Attachment B

Stakeholder Feedback Forms and PacifiCorp's Responses
throughout the 2021 IRP Development Cycle (as of
December 31, 2020)

2021 Integrated Resource Plan

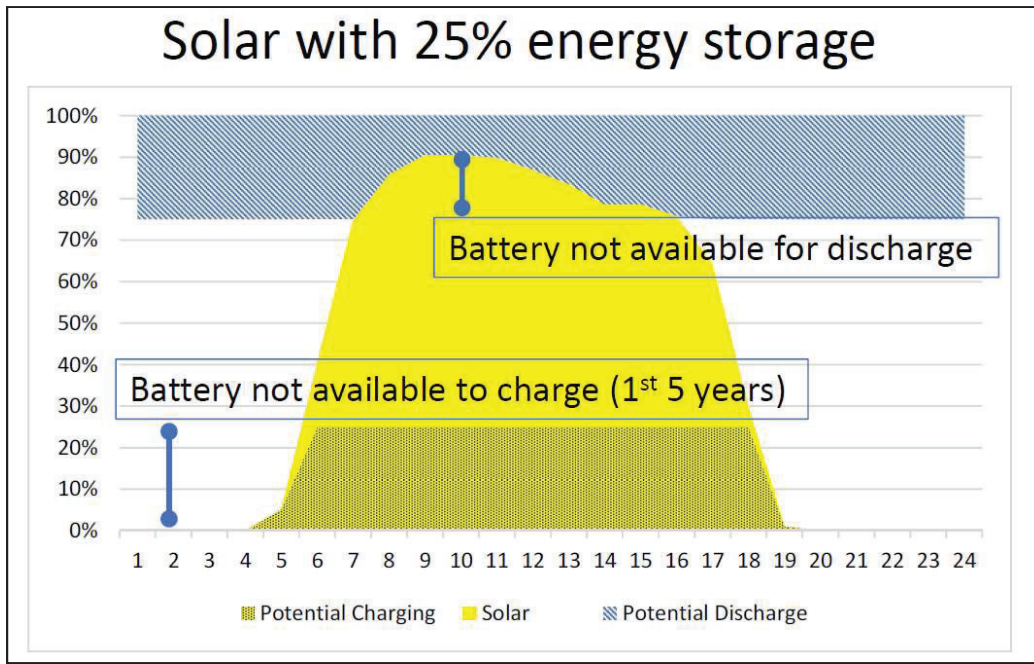
2. See page 30 of the DSM I and III CPA chapter from the 2019 IRP. What does it mean for a DR pricing program to have a useful life of ten years? What is the reasoning for using a ten year lifespan?

Demand-side management (DSM) options are assumed to have both one-time startup costs and ongoing annual costs. Essentially, a “program life” assumption is used to amortize one-time costs over the period for which the pricing option might be offered. The 10-year assumption reflects that PacifiCorp would likely offer a new Class 3 DSM rate option for a number of years, but that over time, the rate may need to be redesigned or discontinued based on changes in enabling technology options and adoption, customer preferences, resource needs and value, or other considerations.

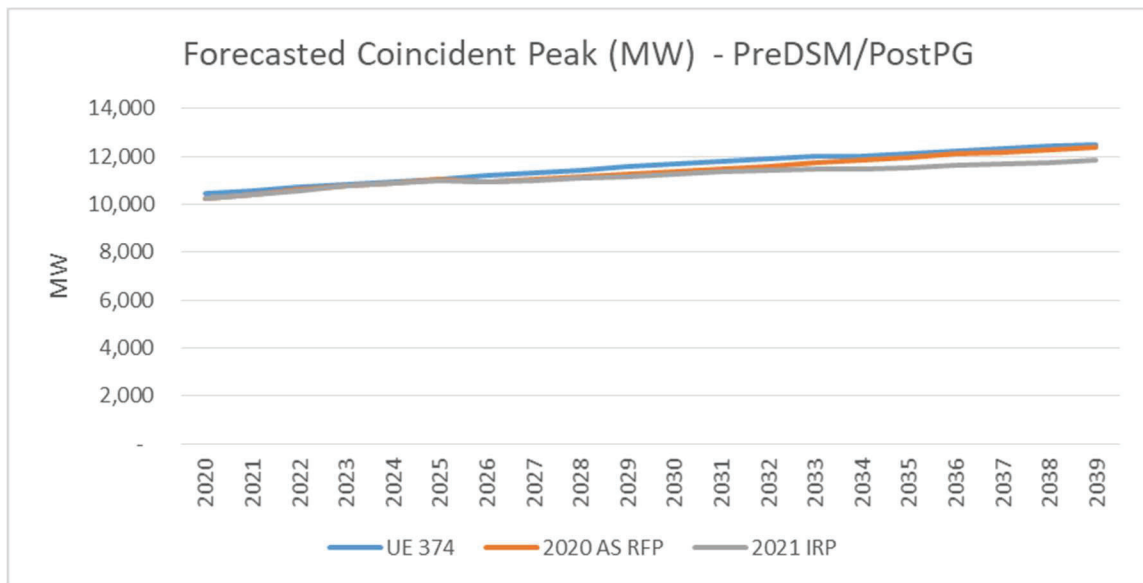
- Please provide a chart showing a comparison of the load forecast in the UE 374 rate case, the updated load forecast used in the 2020AS RFP, and the current load forecast for the 2021 IRP.

Please refer to the figure below, which compares the coincident peak forecasts used in the requested filings. Of note, the forecast results presented are representative of forecasted loads before accounting for the DSM program impacts and after accounting for private generation impacts.

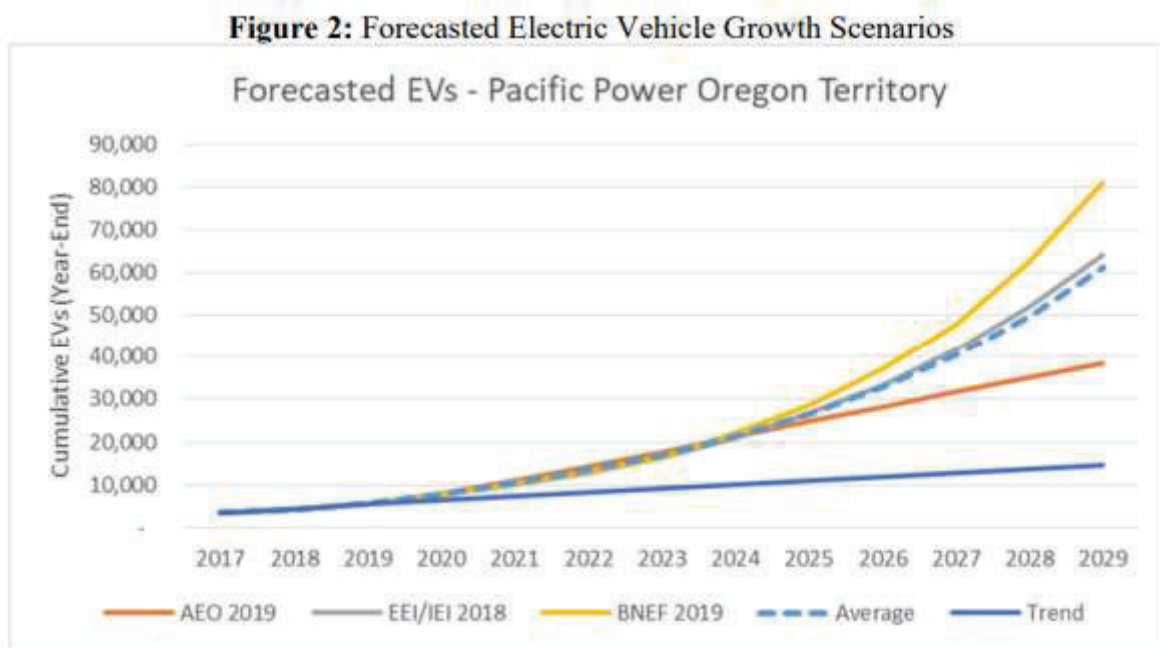
7. In Figure 2 of PacifiCorp's UM 2056 reply comments, the sources averaged to produce an EV growth rate grew faster than the EV adoption 'trend' in PacifiCorp's Oregon service territory. What evidence suggests the EV growth rate in PacifiCorp's Oregon service territory will become as high as an average of the AEO, EEI, and BNEF forecasts?

Figure 2 relates to how electric vehicles (EVs) were forecasted for the 2020 Transportation Electrification Plan in Oregon, but was not the source for forecasting EV load growth in the 2021 IRP load forecast. The EV projections used in the 2021 IRP load forecast were developed in April 2020 and were based on current and expected electric-vehicle adoption trends at that time. These projections were incorporated as a post-model adjustment to the residential and commercial sales forecasts.
